REF: JD 02/91

REF: JD 08/92

ISSUE NO: JD 18/92

- MODEL** : XJS ALL MODELS
- SUBJECT** : WINDOW LIFT MOTOR / REGULATOR ASSEMBLIES
- CUSTOMER CONCERN** : Poor operation / sticking / noisy.
- ADVICE TO CUSTOMER** : Installation of a revised motor or a motor regulator assembly (which incorporates a new motor) will overcome sticking or noisy operation.
- New window lift motors have been introduced in production from VIN 184117.
- DEALER ACTION** : Yes.
- REPAIR METHOD** : Window lift assemblies incorporating the new motor are fully interchangeable with previous assemblies. All motors will be supplied with the necessary additional parts for fitment to vehicles prior to VIN 184117. If the new motor is required to be fitted to vehicles after VIN 184117, the additional parts supplied with the kit should be discarded. For details of part numbers and components relative to VIN, please refer to "Parts Information" below.

FIG 1

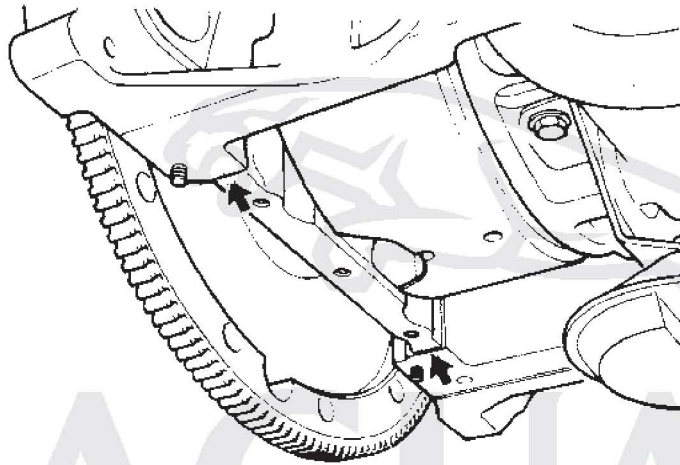
A bead of RTV sealant approximately 3 mm wide and 10 mm long should be applied in the middle of the joint line between the cylinder block and the rear main bearing cap in two positions (Fig 1) before the sump sandwich gasket is fitted.

FIG 2

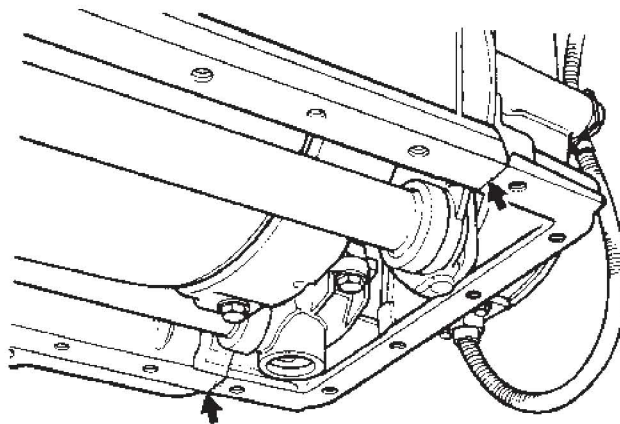
A small spot of RTV approximately 3 mm diameter, should be applied in the middle of the split line between the timing cover and the sump face (Fig 2), after the paper timing cover gasket has been shaved and just before fitting the sump sandwich gasket.

FIG 1

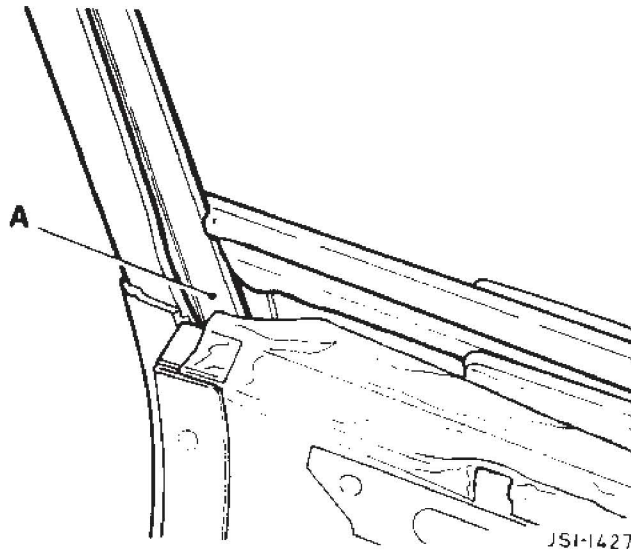
1. Remove the door trim (refer to S.R.O. 76 34 01) to gain access to the door glass window lift regulator assembly.
2. Disengage the regulator assembly from the door glass and allow it to rest in the lower door panel.
3. Place hands on either side (surface) of the door glass, then move the glass up and down. Refer to Fig 1, Point 'A'. The glass movement becomes restricted at this point as full contact is made between the glass and upper to lower guide channels. Close observation of the glass channel seal at the foul point 'A' will invariably show signs of pressure marking and wear.

Note: When excessive wear is apparent on the inner surface of the seal, it MUST be renewed.

FIG 2

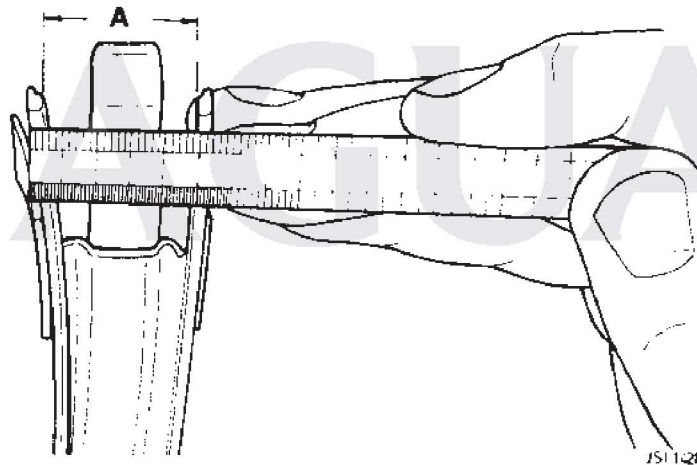
4. Remove the lower door glass channel from the door and place it on a work bench.
5. Refer to Fig 2, which shows the lower guide channel being measured at the position it must be opened out to prevent the door glass sticking. The nominal dimension at this position should be 19.8 to 20.8 mm; subsequently the channel should be opened up to 26.0 to 28.0 mm.

FIG 3

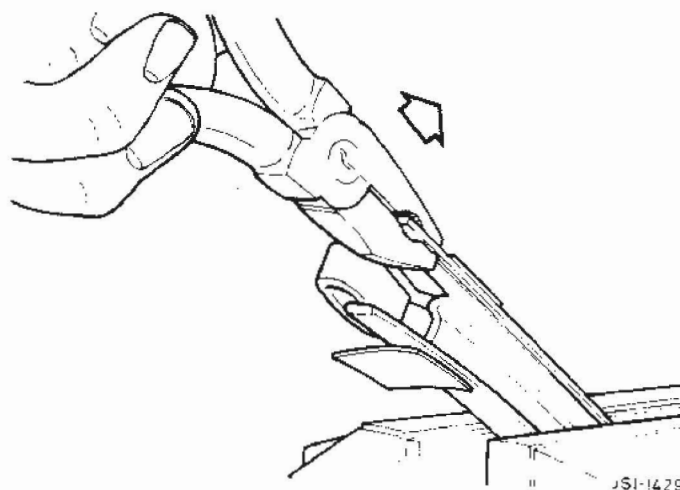
6. To open-up the channel, using soft face jaws, secure it firmly in a vice (Fig 3). Using a pair of pliers; equally bend each side of the channel outward until the increased channel width of 26.0 to 28.0 mm is achieved (A Fig 3).

FIG 4

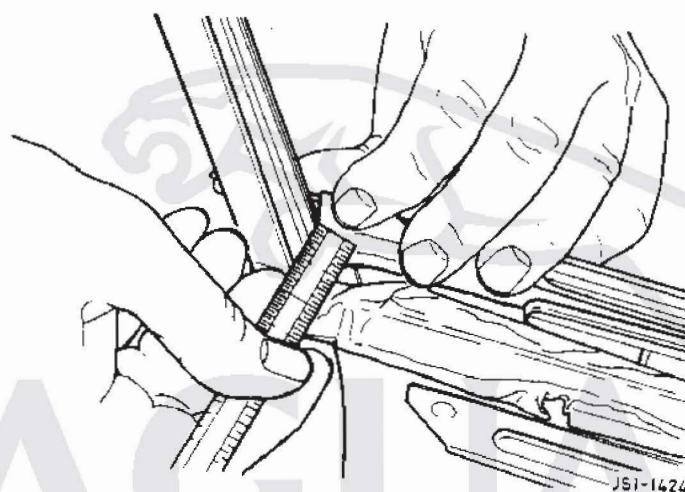
7. Refer to Fig 4; using an engineer's steel rule, measure the external width of the frame as shown. The correct dimension should be 19.5 to 20.5 mm.

8. If this dimension is less than 19.5 mm, the door glass movement will still be restricted at this point. Should this dimension be correct, items 9 to 11 can be disregarded. When this width is less than 19.5 mm, the door/window frame channel will have to be opened out.
9. To open out this channel, insert a 15 mm thick steel drift approximately 12 cm long x 25 mm wide into the channel as shown in Fig 5.

FIG 6

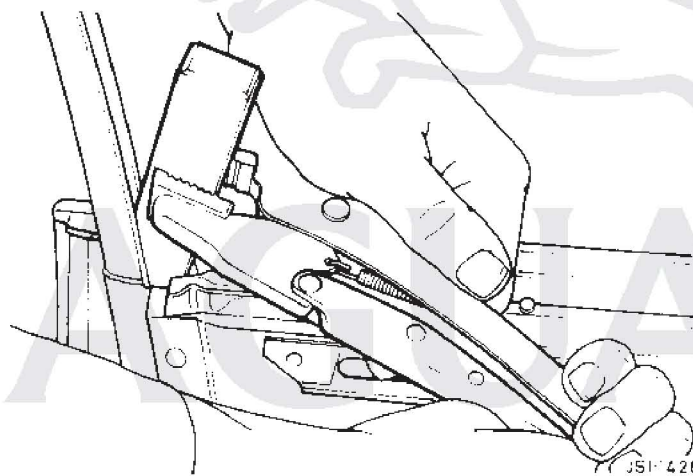
10. Using a pair of pipe grips secured to the drift, twist the drift in the direction shown in Fig 6. This action should be repeated until a dimension of approximately 21 mm is achieved at the position shown in Fig 4. This 0.5 mm increase above the upper limit of 20.5 mm, will compensate for any "spring back" of the channel due to integral latent stresses.

FIG 1

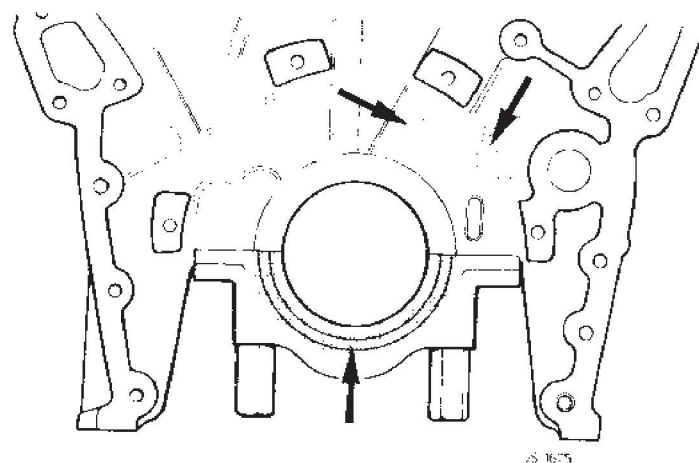
In most cases, the new pump can be used as a direct replacement with no modification to the block; however, in some cases, a foul condition may exist between the pump and certain areas of the old sand-cast block. To check for any foul condition, the pump should be offered in the correct position to the mounting bosses. If it lies flat against the bosses, the condition is correct. If the pump lies proud of the bosses, material should be removed from the foul area of the block (refer to shaded areas in Fig. 1 for possible foul areas) by careful use of a rotary file or similar implement.

FIG. 1

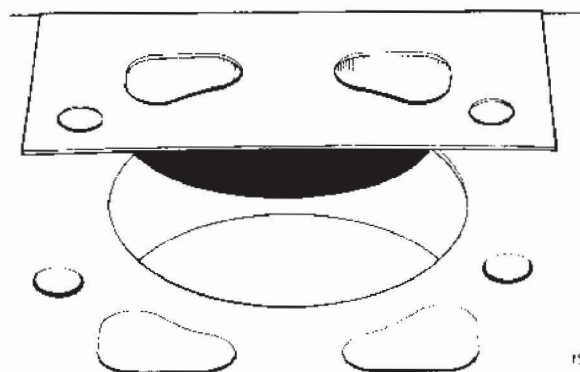
Make a paper template of the cored holes in the cylinder block that correspond with the affected water holes in the head. To orientate the template to the head water holes, include the cylinder head bolt holes on the template. (See Fig. 1)

FIG. 2

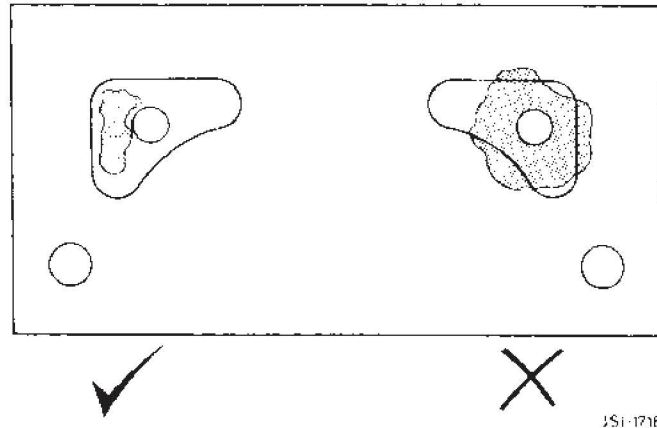
ONLY IF THE EROSION ON THE HEAD OVERLAPS THE CORED HOLE CUT-OUTS SHOULD THE HEAD BE CHANGED.

If the erosion is within the cut-out the cylinder head should be refitted in the normal manner.

FIG 1

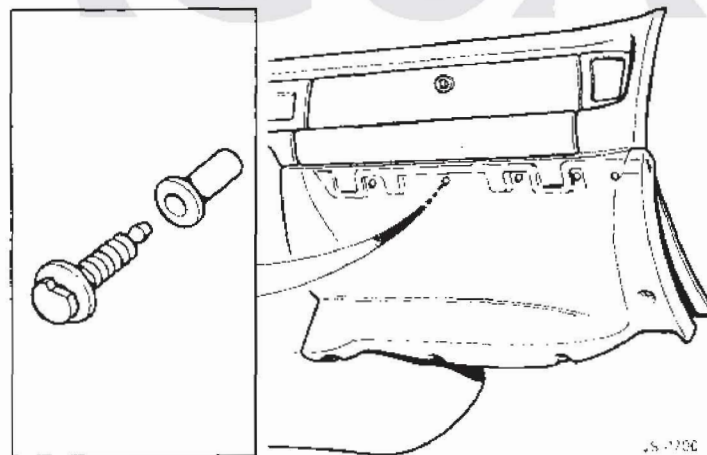
The visual appearance of the facia glovebox lid hinges has been improved on all vehicles built from VIN 658676. Hinges fitted to cars from this VIN are now finished in black.

FIG 1

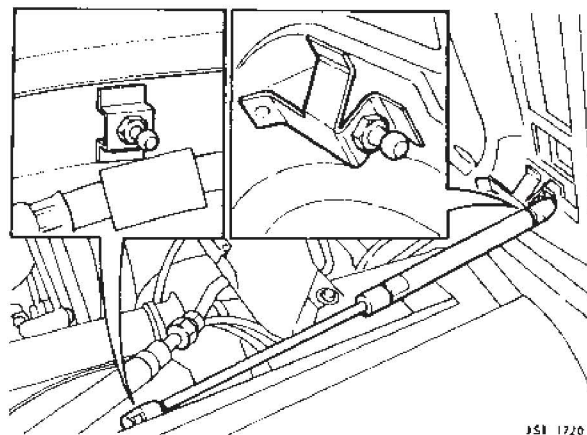
To provide a positive method of supporting the XJ-S bonnet when in the fully open position, a locking support strut is now fitted to the L.H. side of all bonnets from VIN 184672. This revised strut has been designed to be retrofittable to all XJ-S vehicles.

- * Unlock the bonnet and support it in the fully open position – use a wooden wedge.
- * Unbolt and remove the L.H. strut. Discard this strut and its securing bolts.
